Private Fuel Storage, L.L.C.

June 2, 2000

COMMITMENT RESOLUTION LETTER #34
DOCKET NO. 72-22 / TAC NO. L22462
PRIVATE FUEL STORAGE FACILITY
PRIVATE FUEL STORAGE L.L.C.

A meeting was held on May 25, 2000 in San Antonio, Texas between Private Fuel Storage (PFS), Stone and Webster (S&W), and the NRC/CNWRA to discuss several open issues remaining with the Private Fuel Storage Facility (PFSF) Safety Analysis Report (SAR). The topics discussed and the PFS actions necessary to resolve these issues are outlined below.

EDERER		INCORPORATED		S. BROS.	
150/25 TON SEMI-CANTILE CRANE		PRIVATE FUEL STORAGE FACILITY		SHEL VALLEY, UTAH	
PA-2190		-		C

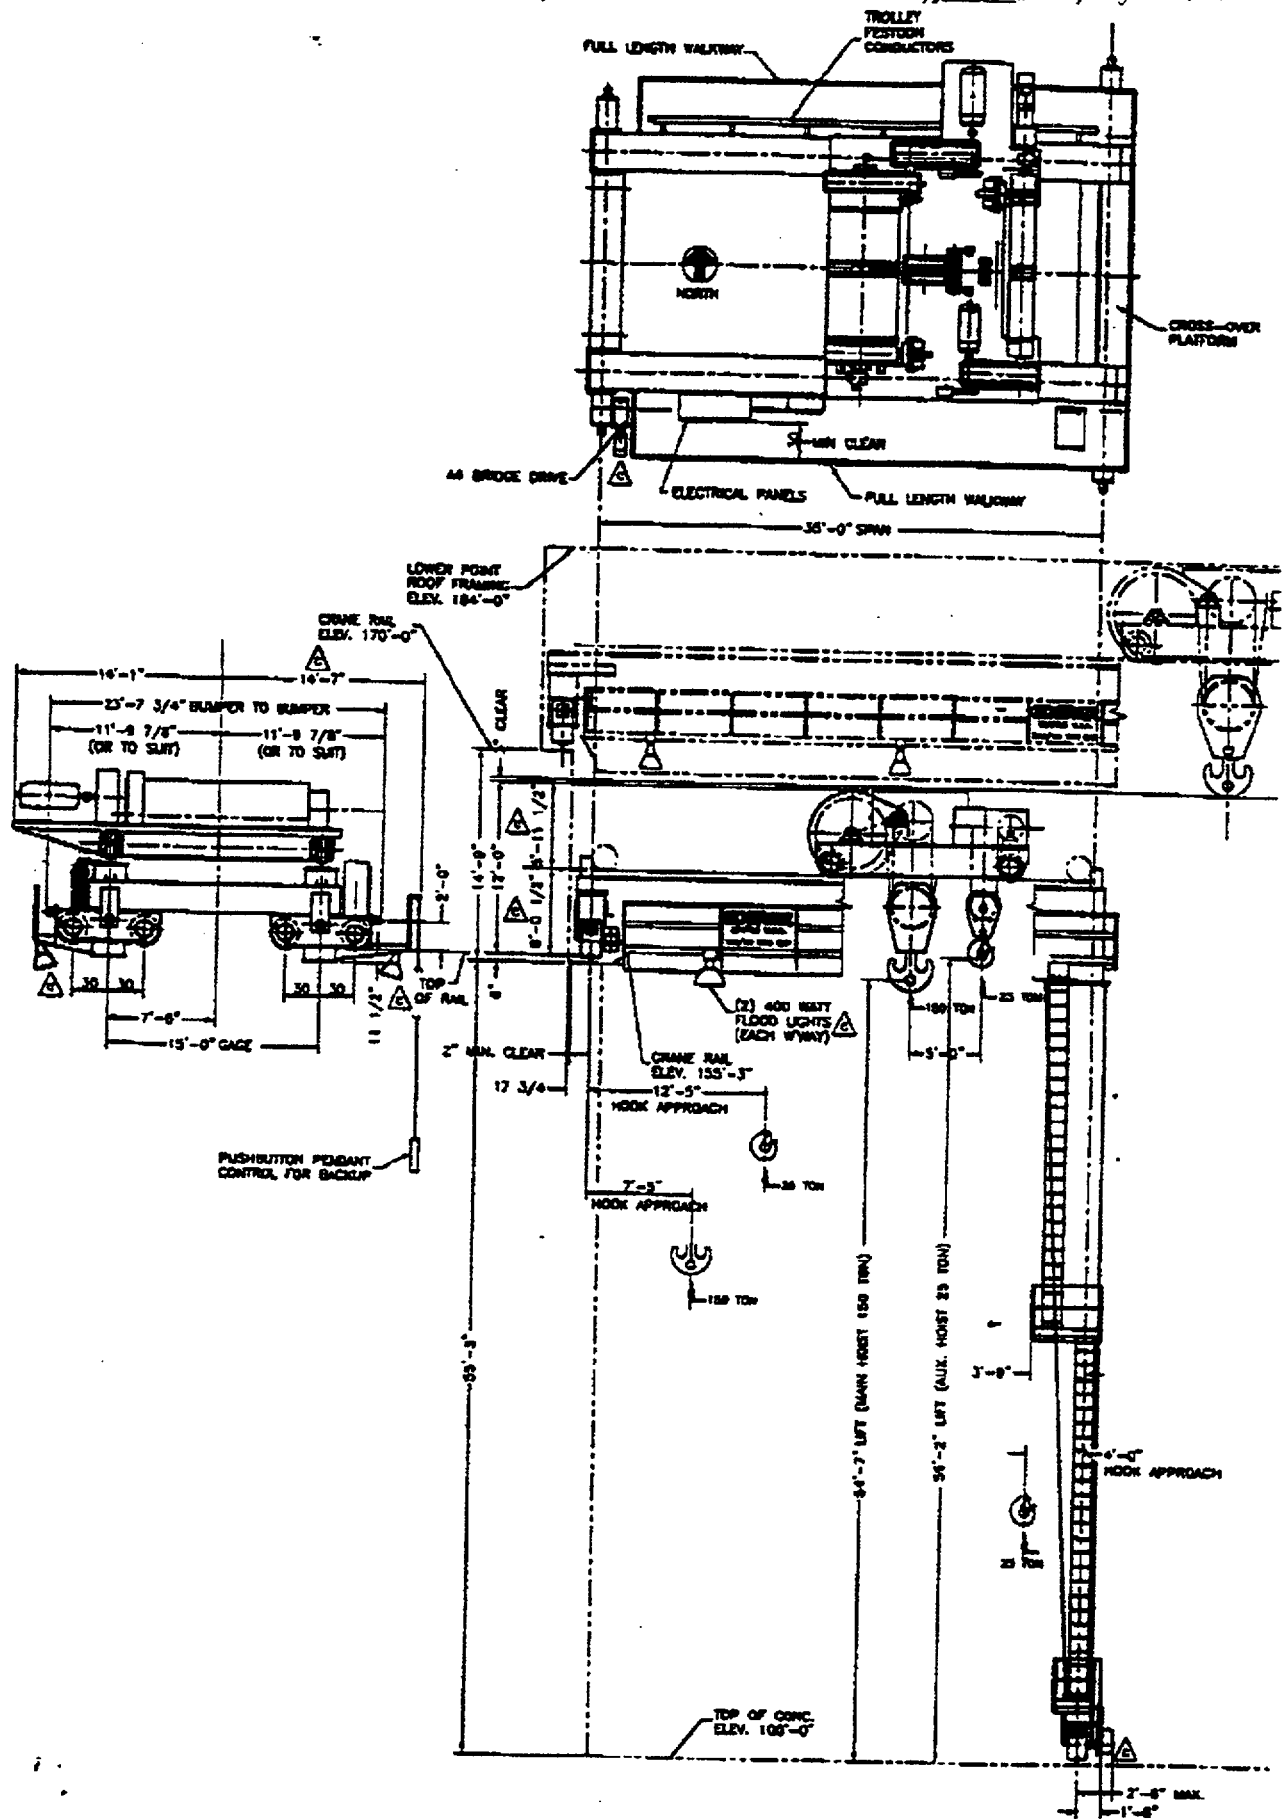
For the 150T gantry crane the vertical peak change is +14% on the west end and +8% on the east end. The N-S lateral forces are governed by wheel slip and will remain constant. The E-W lateral peak change is +100% on the west end and -17% on the east end. The equalizing sill, end tie, and gantry trusses are at low enough % allowable stress that they should remain unchanged. The bridge girder, trolley truck and trolley girder section moduli would increase by approximately 12%. The gantry leg section modulus would increase approximately 50% at the top end and remain the same at the bottom. The joints at the girder/leg interface and the girder/truck interface would have to increase in strength to handle the increased E-W lateral loading. The bridge trucks will be affected by the vertical peak change and the large E-W horizontal peak change at elevation 170 ft. They are however at a % allowable stress of $\approx 75\%$, similar to the bridge crane. The section modulus for the trucks would then have to increase approximately 10%. See Appendix A for a similar sample calculation. In conclusion, we expect that the semi gantry crane will still fit in the same envelope as shown on PA-2190, Rev. C but will be somewhat heavier.
